## **INQUIRY INTO WINDSOR BRIDGE REPLACEMENT PROJECT**

**Supplementary  
Submission  
No 114b**

**From:** Peter Nicholson  
**Sent:** Thursday, 19 April 2018 6:09 PM  
**To:** Portfolio Committee 5  
**Subject:** Windsor Bridge project

**Figure 6: Location of the recorded above water features.**

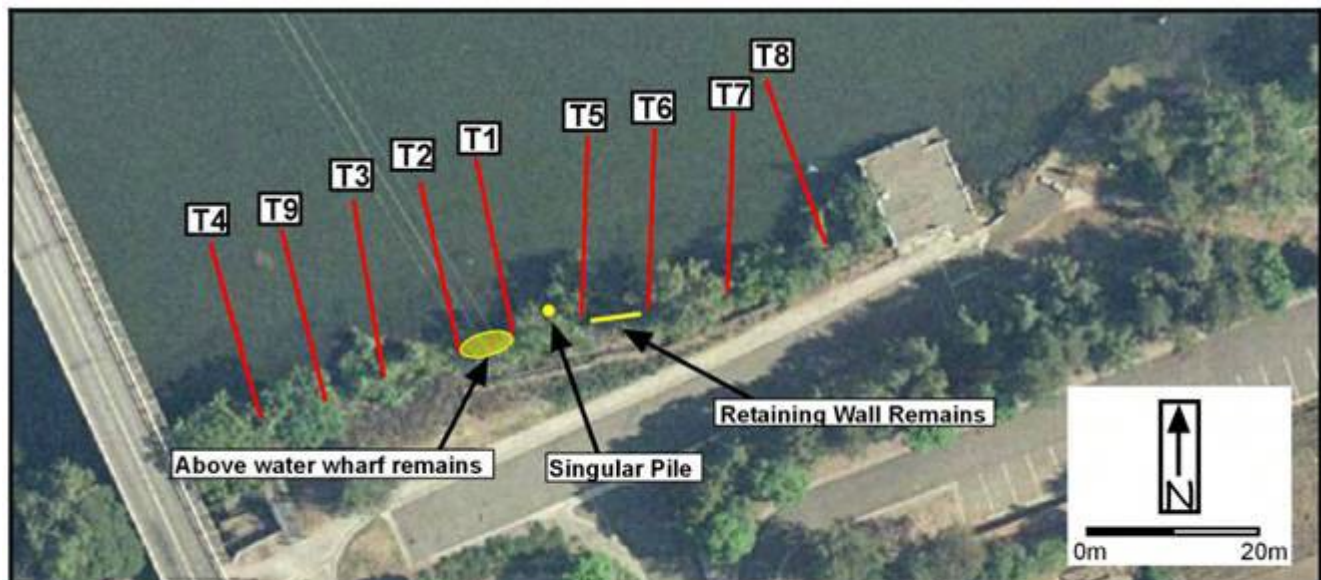
The Cosmos report indicates in Figure 6 that the remains found consisted of:

- Above water remains consisting of 3 beams resting on 2 or 3 walers with large iron bolts
- A singular pile
- Retaining wall remains

Note Figure 6 shows the "old" wharf which was replaced with the current wharf in 2014 according to the SCMP.

While the identified remains are still in situ, the area between T4 and T2 in Figure 6 has been found to contain further remains including the end point of the brick barrel drain, and additional piles have been located within the "above water wharf remains" between T2 and T1. These additional "finds" were easily visible once the vegetation was removed.
